Pauly's Pockets - modification for lunette - email from Barbara Dill

Subject: Re: Pauly's Pockets - modification for lunette

As a member of the design committee for the Pauly's Pockets project since its approval in early 2014, I realize that the project has taken a painfully long time to near completion, for Mr. Eja as well as for the town. I'm writing to try to clarify two items in your planner's review for Wednesday's PB meeting:

bd-details-oct-21-2015

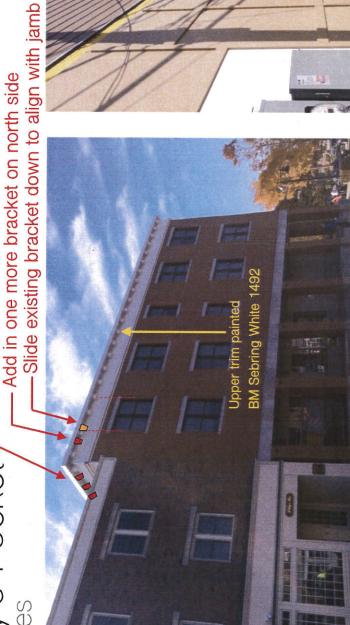
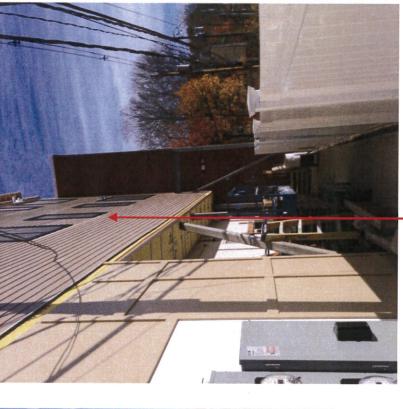
Typical areas that need trim and/or stucco finishing. Trim boards (above right) over wall panels are **not in question**, as they were put there to cover large spaces around the panels that were left by the contractor. Window jams
